## New comment (r01-141, not submitted. Clause 145.3.3.3.5 Page 191 line 48)

### 1. Chane state machine from:

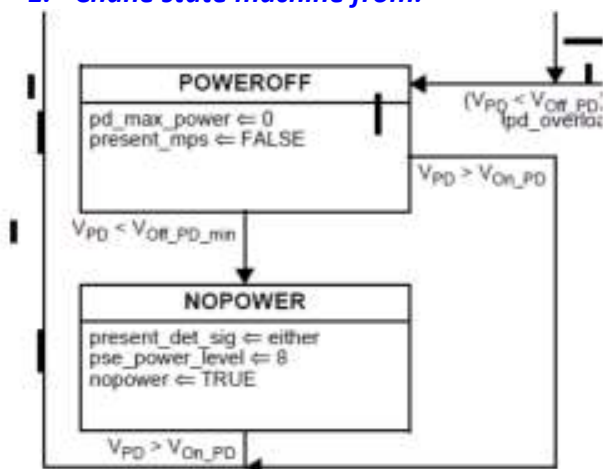
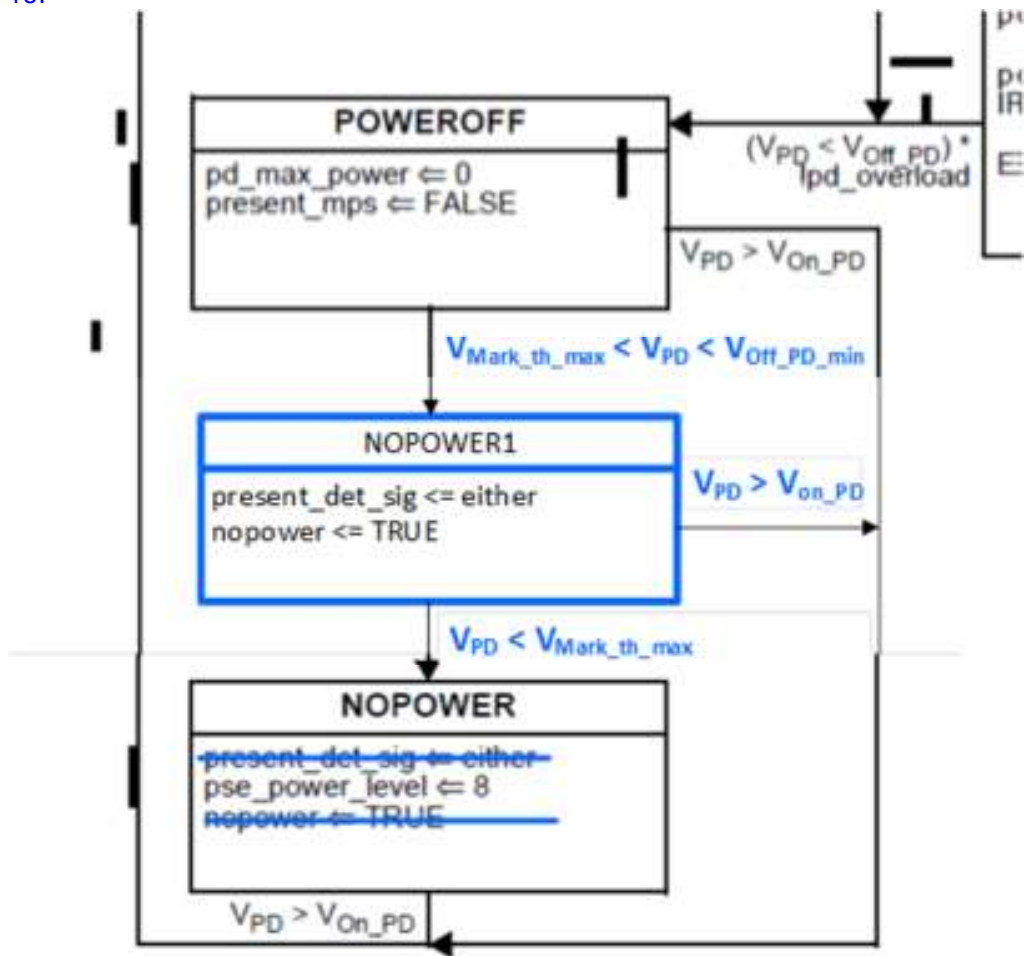
In the PD state machine in NOPOWER we have the assignment  $pse\_power\_level \leftarrow 8$  that may cause overload condition in the PSE whenever the assigned power is lower than the required power.

The overload condition happens when we force compliant PDs in NOPWER that do remember their assigned class (and their  $pse\_power\_level$ ) data to redefine their  $pse\_power\_level$  in NOPOWER to higher power level in NOPWER when PSE has no knowledge about it.

The assignment  $pse\_power\_level \leftarrow 8$  in NOPOWER looks redundant at least if the PD remembers its  $pse\_power\_level$  when PD input voltage is above  $VReset\_PD\_max$  (2.81V), or  $VReset\_th\_max$  (6.9V) which ensures sufficient voltage to PD to keep its memory.

Asking PD to assign  $pse\_power\_level \leftarrow 8$  in NOPOWER for  $VPD < VOff\_PD\_min$  without specifying that the lowest value for  $VPD < VOff\_PD\_min$  is  $VReset\_th\_max$  is the issue.

This comment tries to minimize the exposure of a compliant PD that do remember its  $pse\_power\_level$  to be forced to reassign  $pse\_power\_level$  to 8 which will cause that PD to cause PSE overload which is uncompliant behavior after that PD that didn't go to IDLE was behave in a compliant way.

The proposed remedy is based on reducing the input voltage range in which we are forced to assign  $pse\_power\_level$  to 8 from:  $Vpd < VOff\_PD\_min$  to:  $Vmark\_th\_max < Vpd < VOff\_PD\_min$ .

To:

2. Repeat the proposed changes for dual-signature PD.
